One Tasman Pukeahu Park (1 & 23 Tasman Street, Wellington). Urban Design Assessment

13 April 2023 (Rev3)

Figure 2.4: Proposed height relative to ODP limit (18.6m AGL)

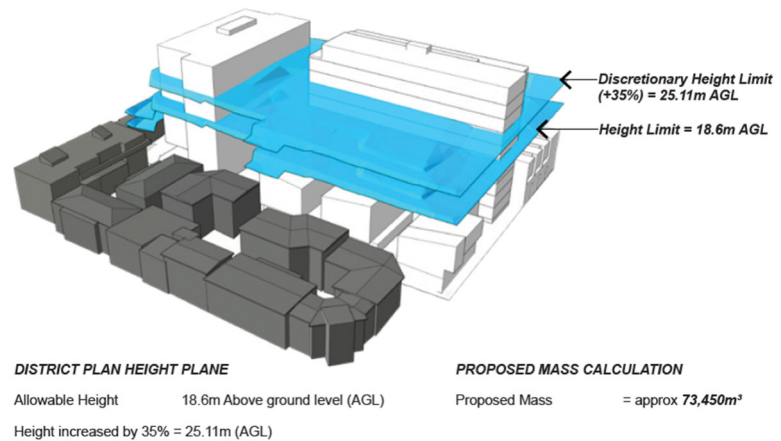
I consider that the Proposal supports the guideline in part except for the height for Building E that should present a visual step down from Building A through removal of one level or noticeable design change to the top level.

Figure 2.8: Building E modulation is apparent in views from the east (ADS Appendix 1)

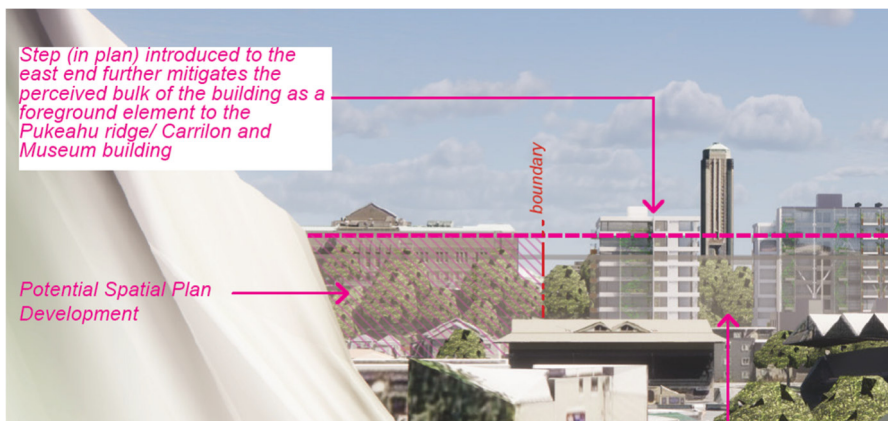
Building E is taller than its neighbours to the south and east and planned (ODP) heights are 10.2AGL vs 18.6m AGL for the site. The eastern and western ends to the building step in plan providing modulation that helps to mitigate bulk (Fig. 2.8). A well-defined base is provided through brick cladding, lobby entrance, live/work and the pronounced canopy fascia. This building however does not deploy the same design features as Building A and I refer to my earlier assessment of the need for a visual step between Buildings A and B that might be achieved through removing an upper level or treating the top of the building as a penthouse structure with noticeable setback, material, and colour change.

Adjusting the top level of Building E would also help mitigate bulk in views from the south of Tasman Street¹⁹ given the lower existing context and lower planned ODP context (10.2m AGL).

I consider Building A supports the guideline and Building E partly supports the guideline, with full support possible through reduced height and/or design treatment of the top level.
